AGENDA – WORKSHOP OF THE CITY COUNCIL OF THE CITY OF PEARLAND, TEXAS, TO BE HELD ON MONDAY, OCTOBER 18, 2010, AT 7:00 P.M., IN THE COUNCIL CHAMBERS, CITY HALL, 3519 LIBERTY DRIVE, PEARLAND, TEXAS.

AGENDA REQUEST
BUSINESS OF THE CITY COUNCIL
CITY OF PEARLAND, TEXAS

SUBJECT: Request of Kerry Gilbert, Agent for Kerry R. Gilbert & Associates, Inc., Owner, for a Joint Workshop regarding amending the Southern Trails Planned Unit Development.

SOUTHERN TRAILS PLANNED UNIT DEVELOPMENT AMENDMENT

EXHIBIT "E"

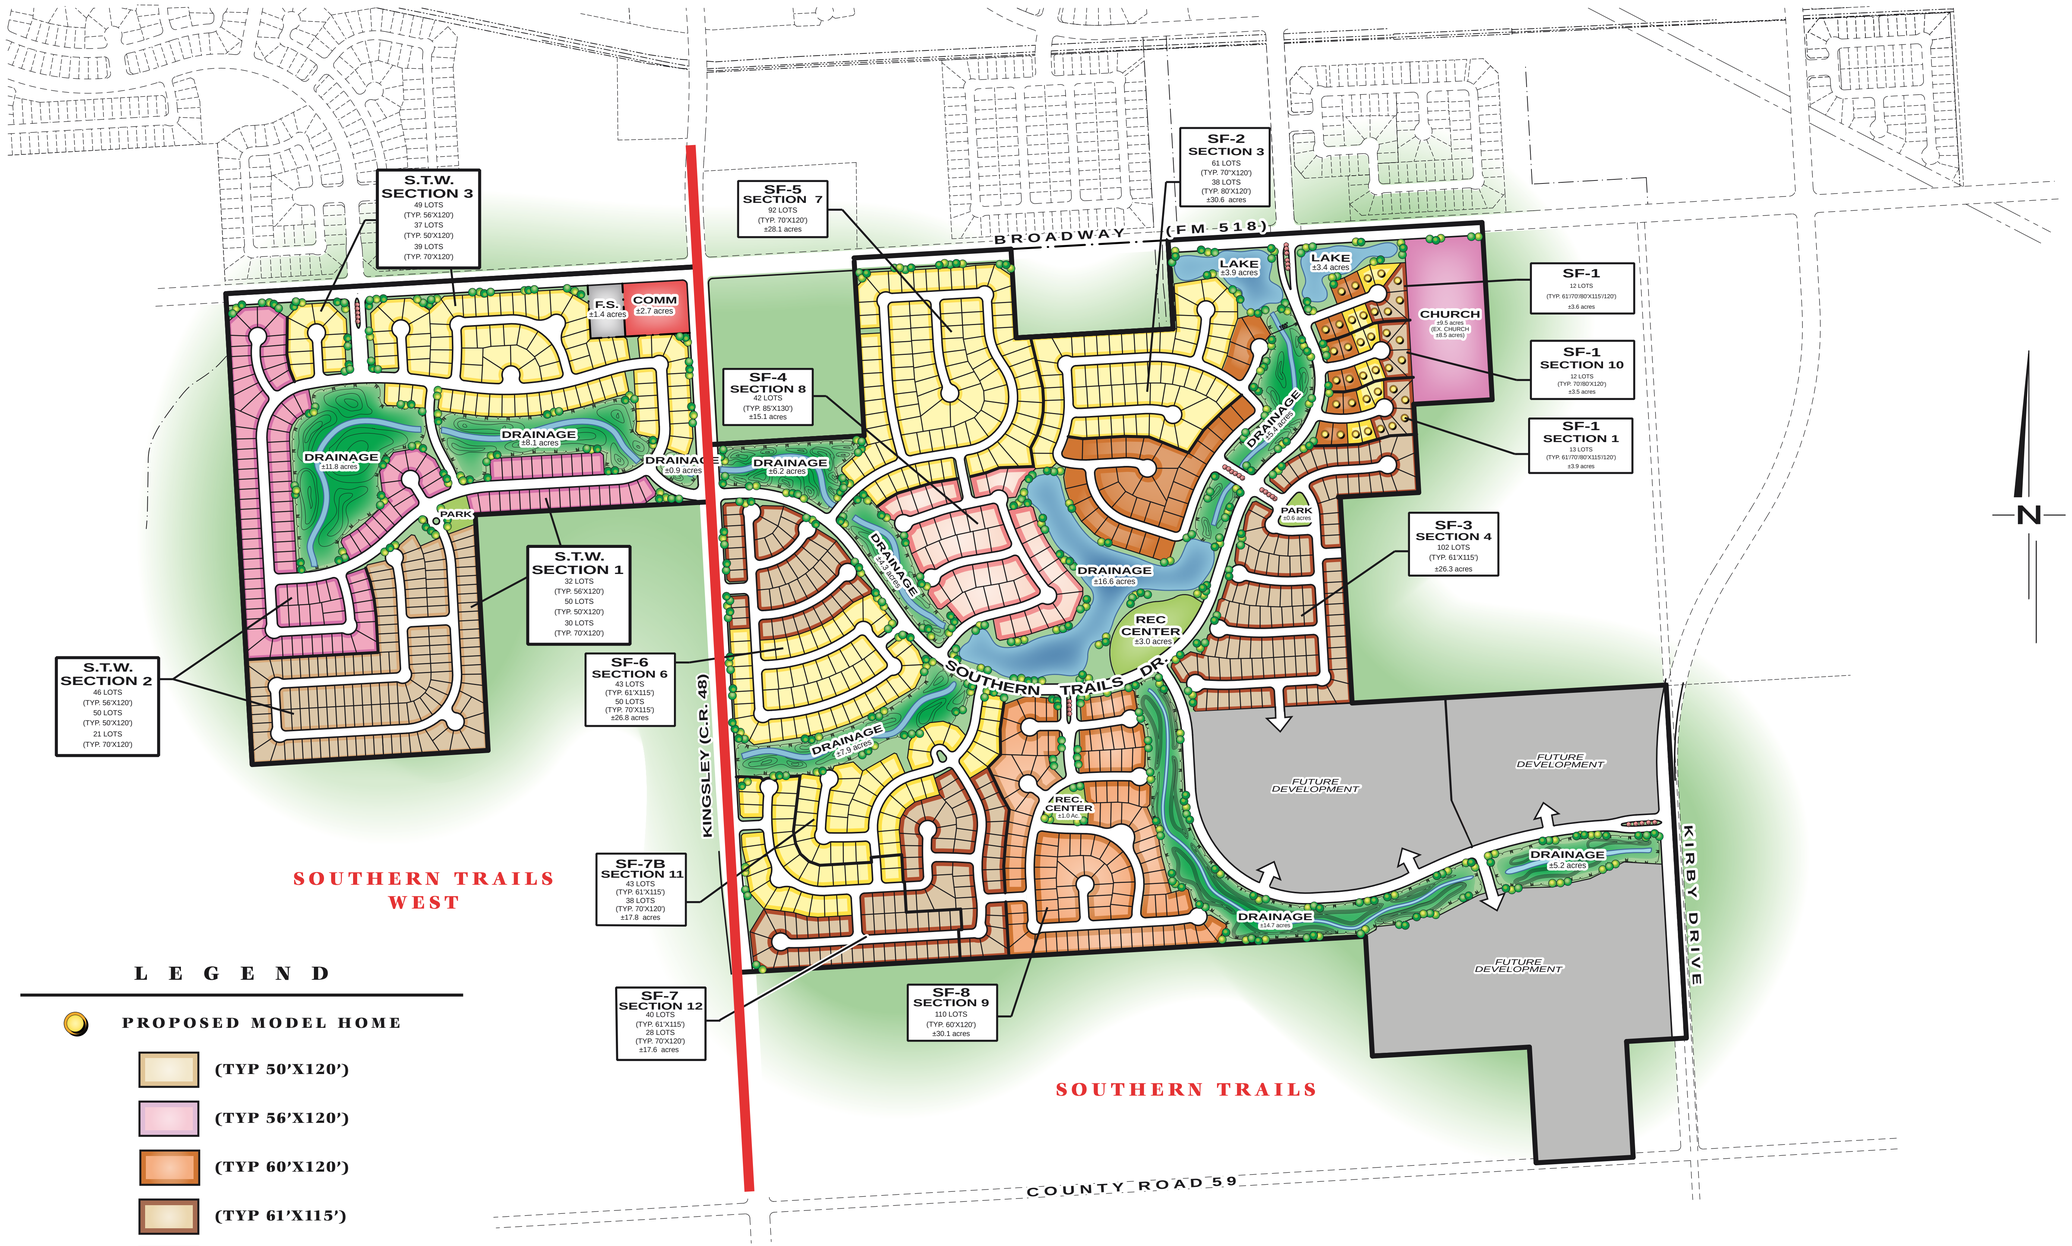
The trail system is a major element to the Planned Development of Southern Trails. The applicant is proposing to modify the existing trail system by removing two out of three pedestrian underpasses and the relocation of the most southerly trail portion. One pedestrian underpass has been constructed at the intersection of Southern Trails Drive and Ashton Oaks Drive. The original document had two other pedestrian underpasses one at the intersection of Kingsley Drive (CR 48) and Southern Trails Drive and another at Broadway Street and Southern Trails Drive. These pedestrian underpasses, as proposed will be replaced by at grade crossings. Under the Goals and Objectives for Southern Trails, the below grade crossings were a feature to promote safety, accessibility and ease of use. The Parks and Recreation Director has voiced concerns of safety with the removal of the pedestrian underpass at the intersection of Kingsley Drive (CR 48) and Southern Trails Drive, as Kingsley Drive road will become a future

120-foot Major Thoroughfare. A relocation of the most southerly portion of the trail system is also proposed.

The original Southern Trails Pedestrian Trail System had a single pedestrian trail located just south of Ashton Oaks Drive and Southern Trails Drive. This pedestrian trail was proposed northerly of the drainage system, whereas the new proposal has the trail on two paths along sidewalks north and south of the drainage system. This modification will still allow this Planned Development to meet its goal of providing a continuous and easily accessible trail system with natural open space.

The Southern Trails Planned Unit Development provided a substantial amount of amenities within the development, including a total of <u>three</u> "Tot Lot parks" of approximately 0.5 acres each. This proposed modification removes <u>one</u> proposed Tot Lot park location. There are still two more "Tot Lot parks" which have to be located within this development. It is staff's opinion that all three Tot Lots parks should be shown on the Trail System Exhibit.

- Pedestrian safety is a concern as Kingsley Drive is a planned 120-foot Major Thoroughfare, especially with the replacement of the pedestrian underpass to an at-grade crossing. The underpass would have provided a safe passage for pedestrians crossing and going to a bus stop located in the vicinity of Kingsley Drive and Southern Trails Drive. Engineering has indicated that no stop signs or street lights will be permitted by the county to assist pedestrians crossing where the underpass would have provided. Pedestrian safety is also a concern at other underpass location just below Broadway Street and Southern Trails Drive as this is the main entrance for the Planned Development. Staff would recommend that the applicant explore other walkable solutions provided in other similar areas.

- Assurance that remaining amenities will be provided, including the remaining two remaining “Tot Lot parks” to provide a total of three as approved.
- Complete Staff report to be completed after thorough review of resubmittal of documentation on 10/07/2010.

At this time, many of the above stated amenities are constructed. However, the Exhibit E Trail System has been updated to depict revisions to the underground pedestrian tunnels and sidewalks. The following revisions are shown on the revised Exhibit E Trail System and are listed below:

- The proposed below grade pedestrian crossing located on Southern Trails Drive south of Broadway, will not be constructed. Instead, the existing six (6) foot sidewalks along each side of Southern Trail Drive coupled with the signal controlled intersection with two-way ramps and crosswalks located at Broadway eliminate the need for the proposed crossing.
- Construct a six (6) foot sidewalk along east side of Kingsley Drive, extending from Southern Trails Drive north to the northern property edge of the Southern Trails development and to install handicap ramps at each intersection.

- Construct a six (6) foot sidewalk along the westside of Kingsley Drive from Southern Trails Drive north to the Commercial site (option for developer to construct or pay City of Pearland in lieu of construction).
- Install crosswalk at grade on Kingsley with appropriate signage and striping, in lieu of a below grade pedestrian crossing (under Kingsley Drive).
- Not to construct a trail along the drainage easement on the southern boundary between Kingsley Drive and Trail Hollow Drive. The sidewalk along Southern Valley Drive provides a pedestrian pathway parallel to the drainage easement.
